<b>Product / Process Change Notification (PCN)</b>	
<input checked="" type="checkbox"/> Major Change <input type="checkbox"/> Minor Change	
<b>PCN Number:</b> PCN_IndHCC_20241226  <b>Affected Series:</b> WE-HCC  <b>Affected Order Codes:</b> See table 1  <b>PCN Date:</b> 2024-09-26 (YYYY-MM-DD) <b>Effective Date:</b> 2024-12-26 (YYYY-MM-DD)	<b>Change Category:</b> <input type="checkbox"/> Equipment/Location <input type="checkbox"/> General Data <input type="checkbox"/> Material <input type="checkbox"/> Process <input checked="" type="checkbox"/> Product Design <input type="checkbox"/> Shipping/Packaging <input type="checkbox"/> Supplier <input type="checkbox"/> Software
<b>Contact:</b> Product Management  <b>Phone:</b> +49 (0) 7942 - 945 5001  <b>Fax:</b> +49 (0) 7942 - 945 5179  <b>E-Mail:</b> pcn.eisos@we-online.com	<b>Datasheet Change:</b> <input checked="" type="checkbox"/> Yes <input type="checkbox"/> No  <b>Attachment:</b> <input type="checkbox"/> Yes <input checked="" type="checkbox"/> No

Before Change	After Change
	 <p>*The inductors are identical; the variation in their appearance is due to differences in the camera's lighting conditions.</p>

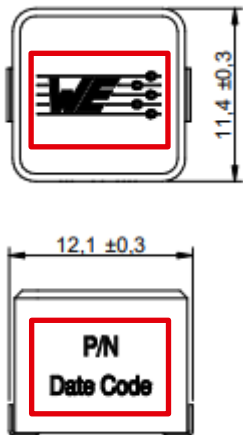
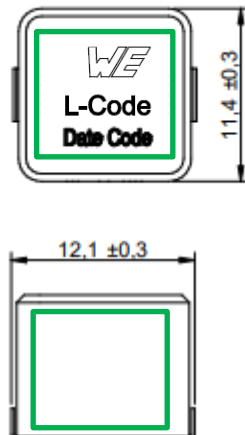
1. Würth Elektronik eiSos will improve the marking from the actual pad printing and ink jet methodology to a laser technology. With this change, Würth Elektronik eiSos will replace the complete part number for an L-Code mark on the top face, and as well we will be able to move the date code from the side to the top surface of the component. The update will apply for the order codes shown in the table 1.
